2000-3 Arapaho Road  
TU Electric - 1999

Re: Arapaho Rd / Edwin Lewis Drive

Re: Arapaho Rd / Quorum Rd

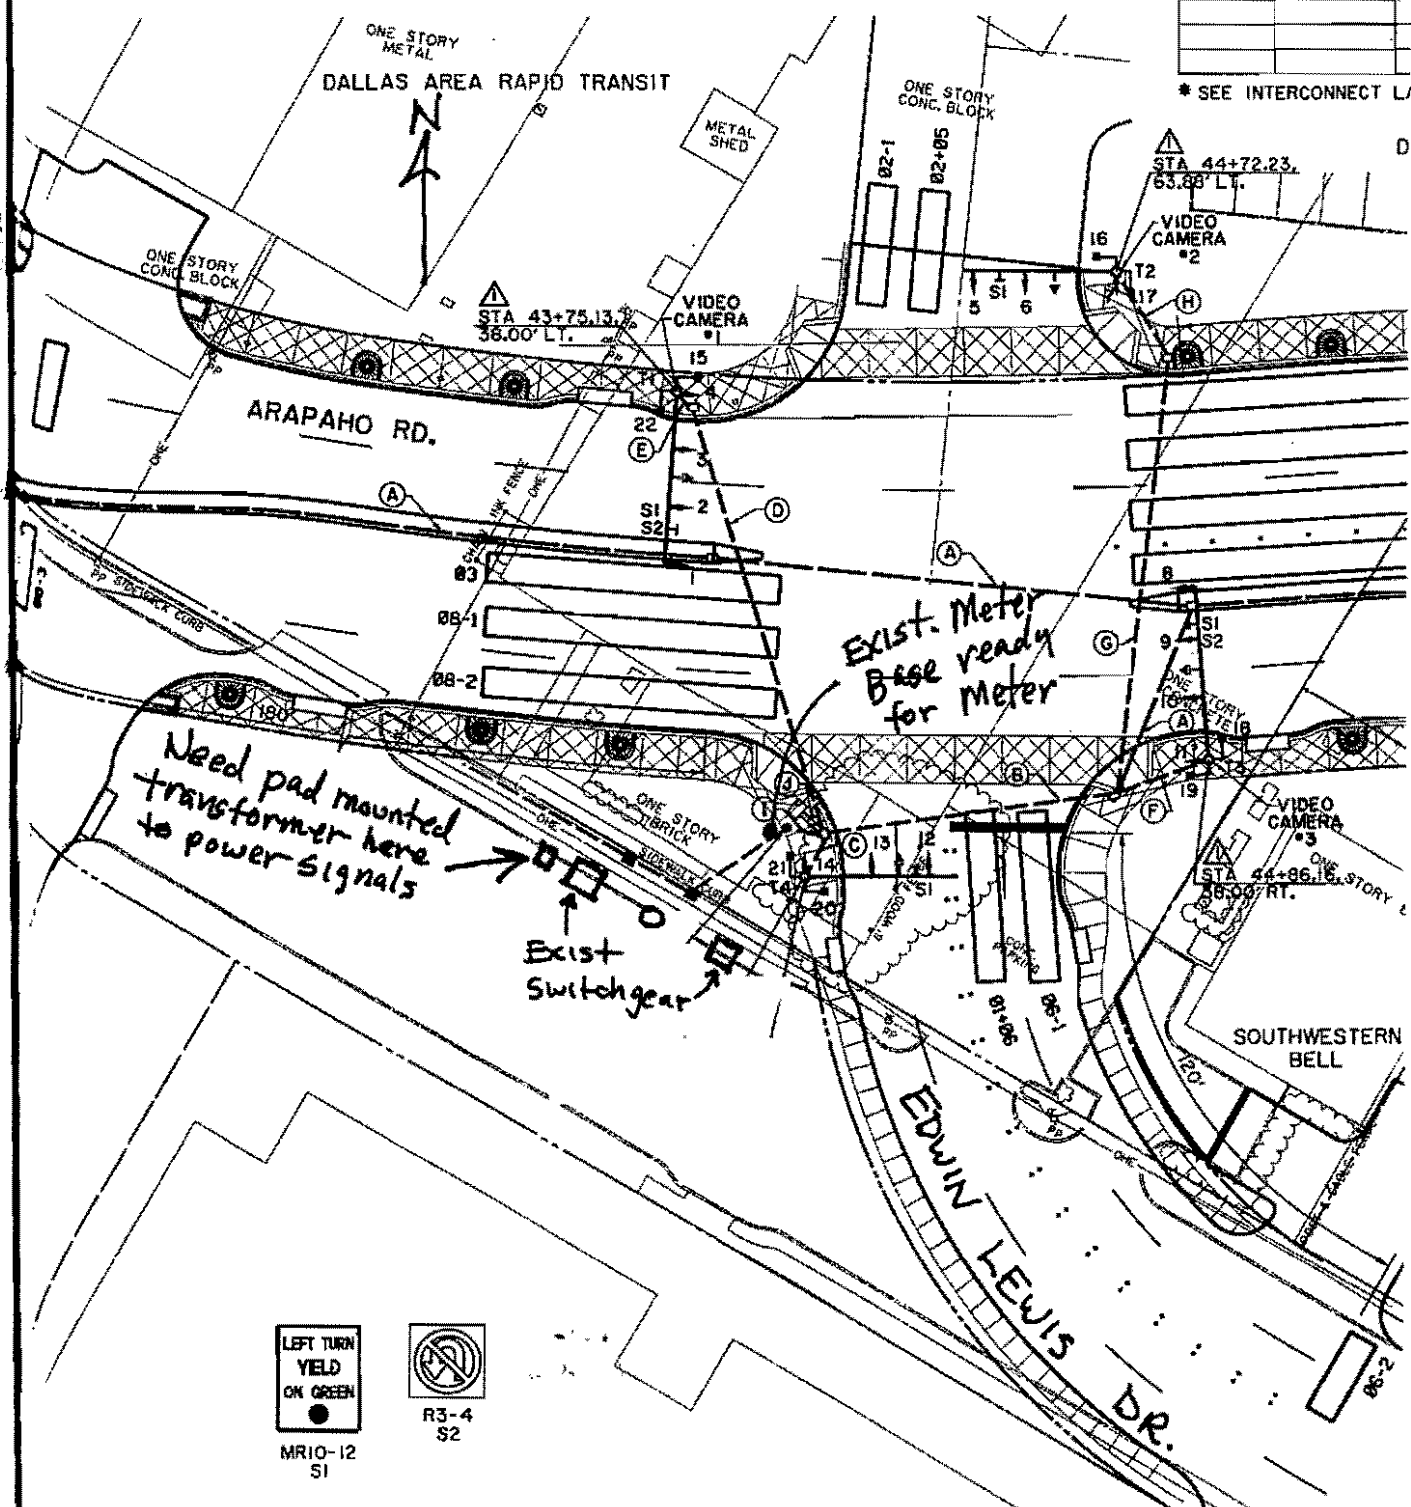
*Attached is a "map" showing  
what needs to be done here.*

*We need a pad mounted  
transformer and a meter.*

# CONDUIT RUNS

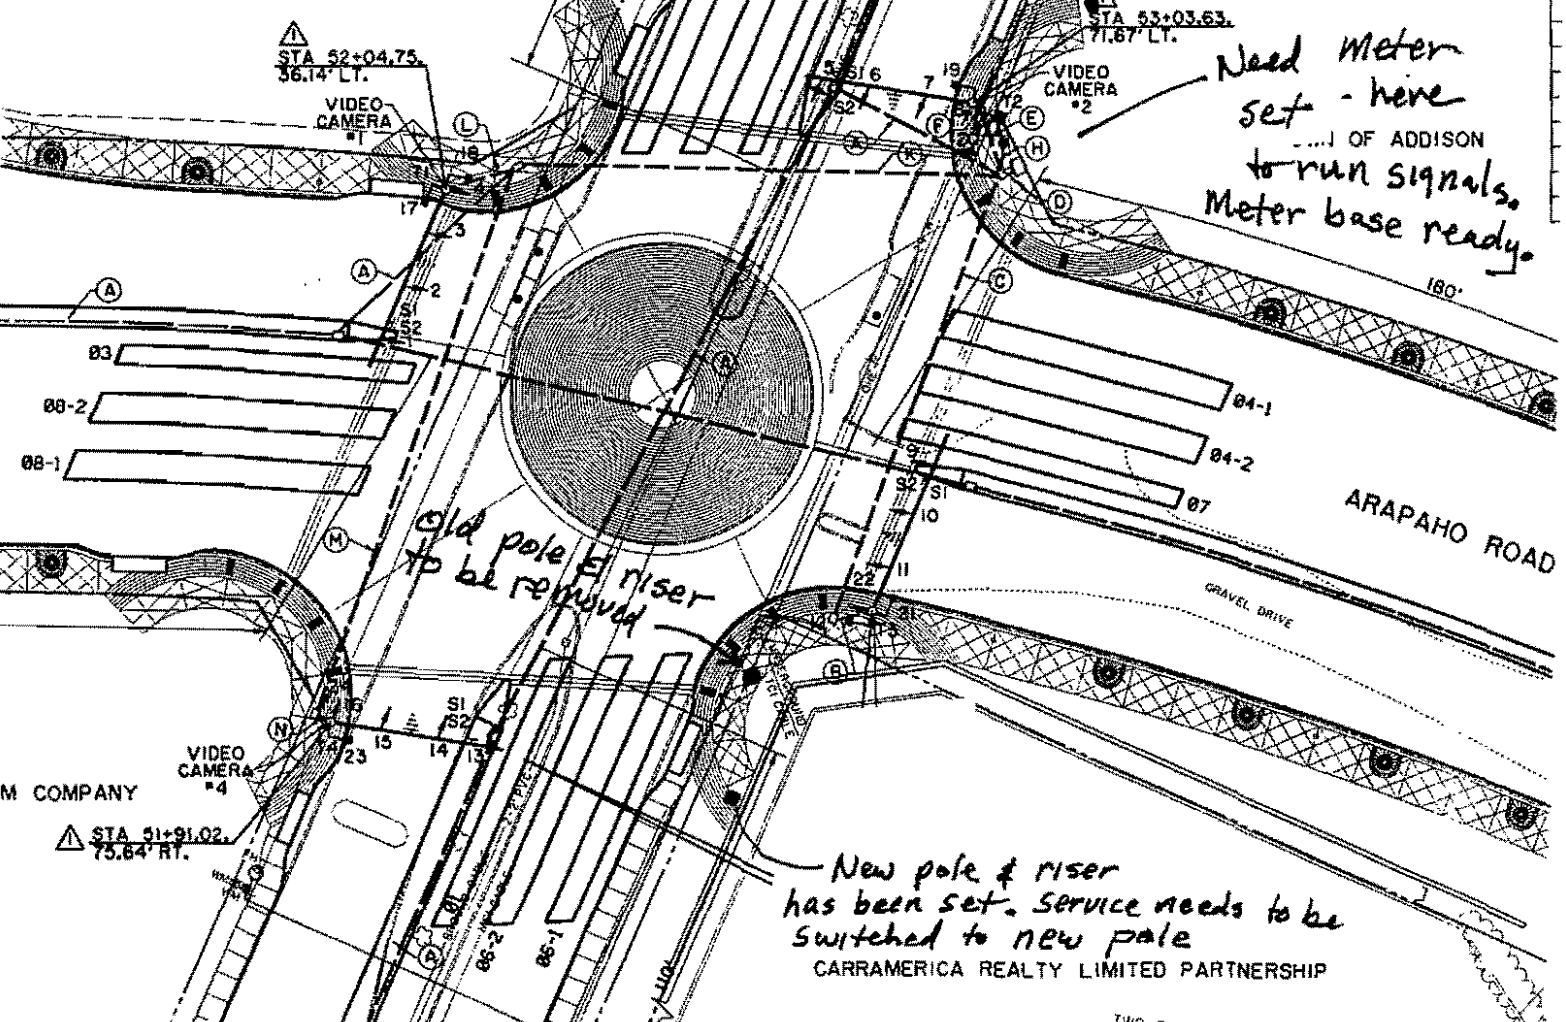
Comments: Attached is a "map" of what  
needs to be done at above site.

We need the meter set immediately  
so we can get the signals working.  
We are waiting on the meter.

Poles to be removed to build Sidewalk

Risers need to be removed.

Old pole & riser to be removed

COPIES	DATE	NO.	DESCRIPTION
5			Drawing showing new streetlight location & new video camera location.

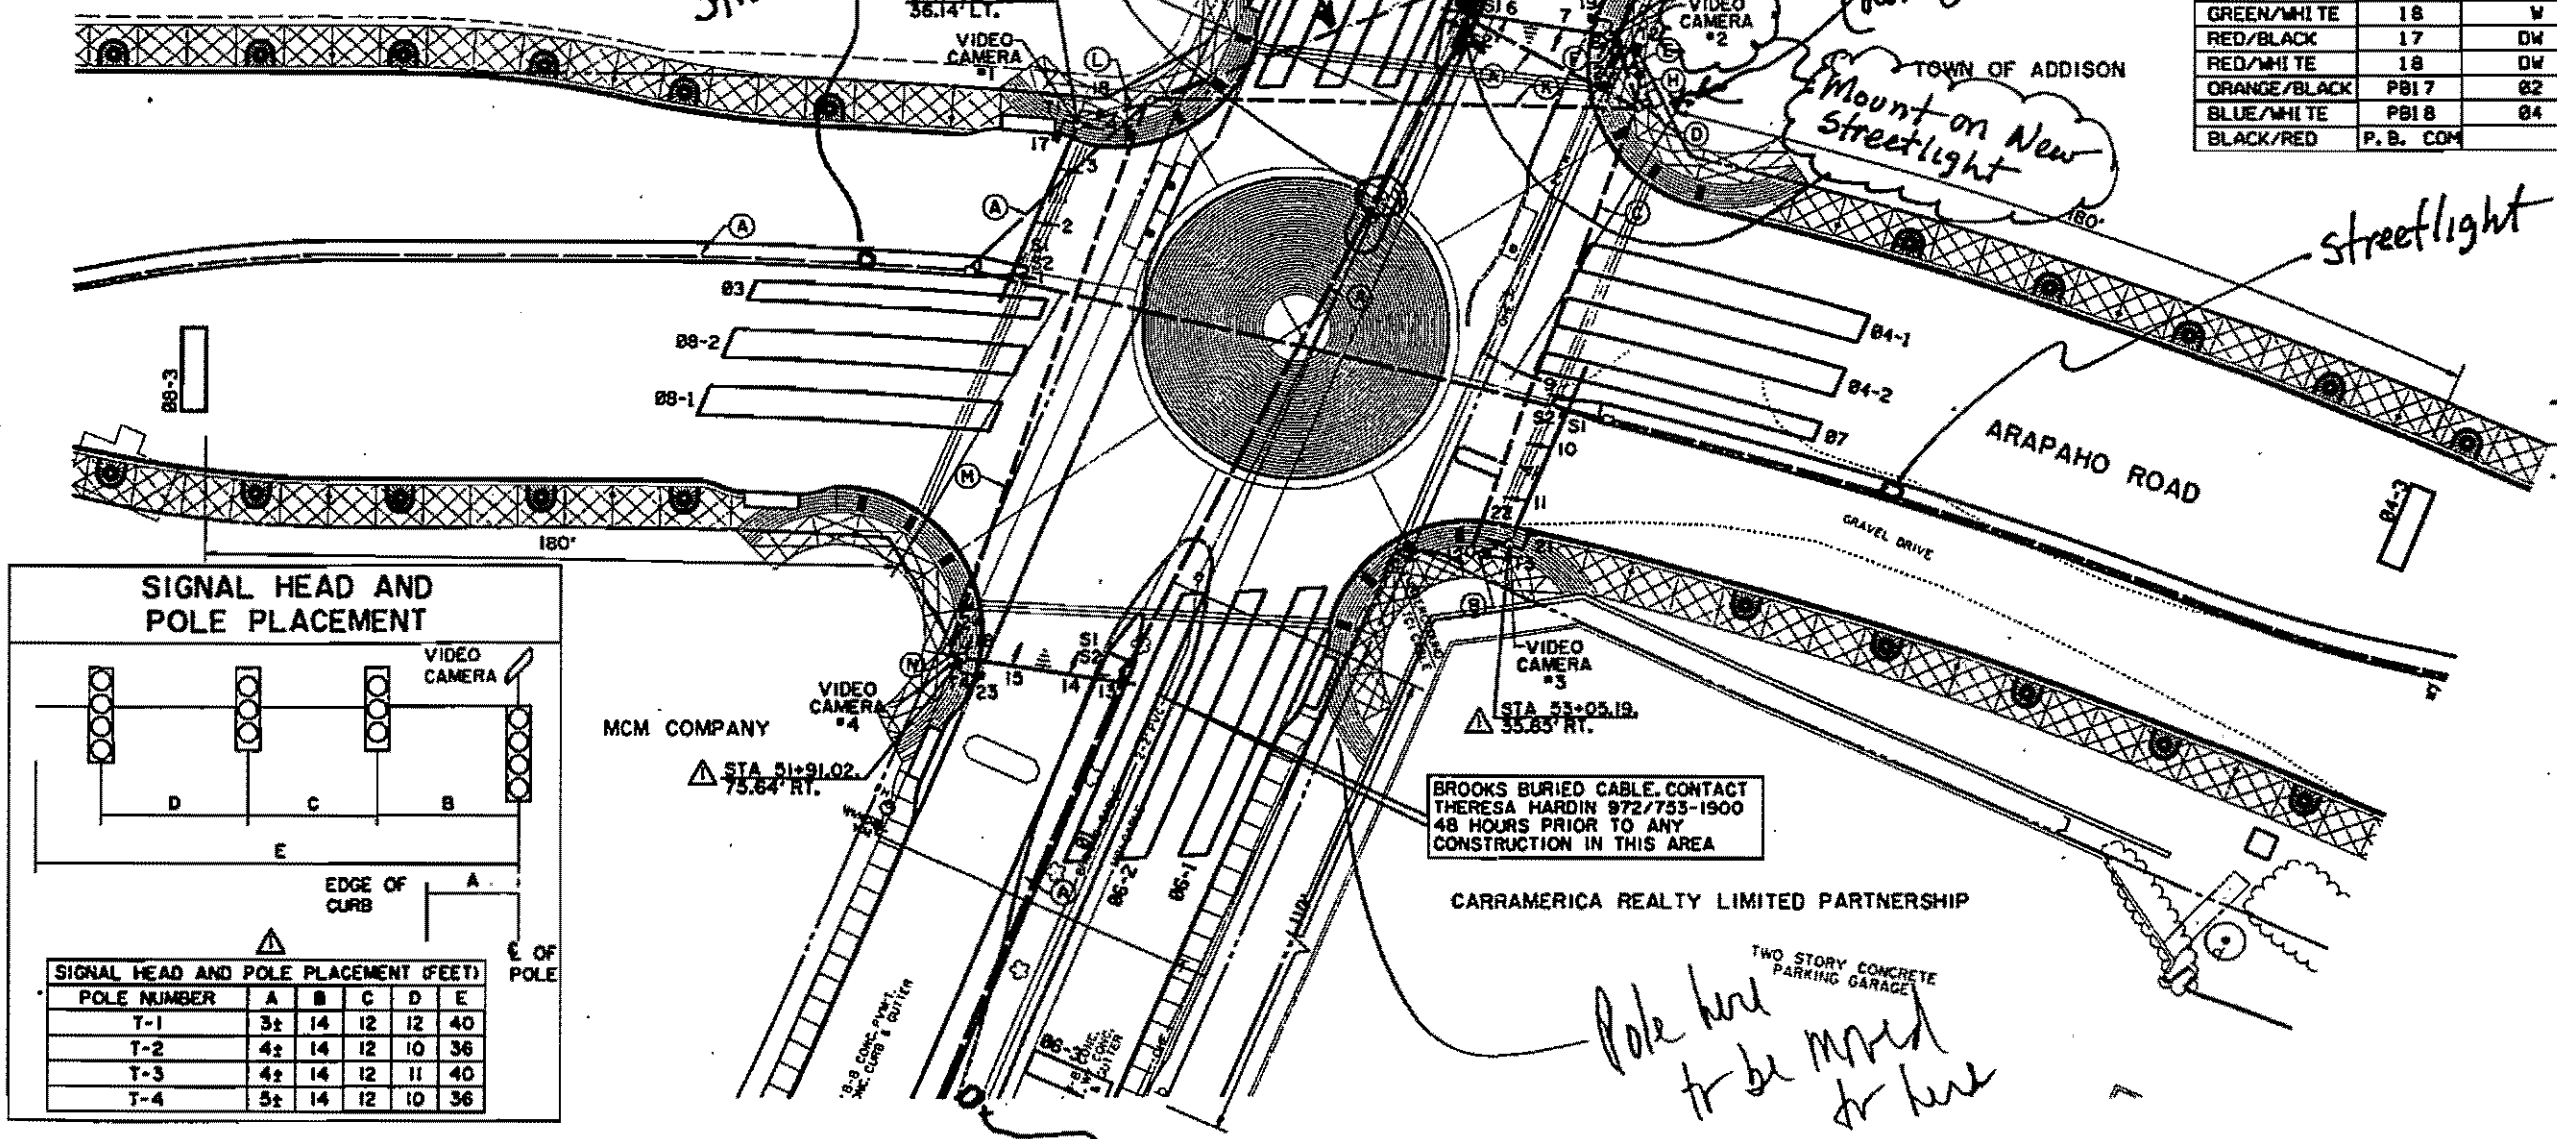
**REMARKS** One of the purposes of the new streetlight location is to provide a better mounting location for the video camera. We should have existing pay items for this work except for conduit up the streetlight for mounting the camera. Please incorporate this change into the work and advise of any additional charges.
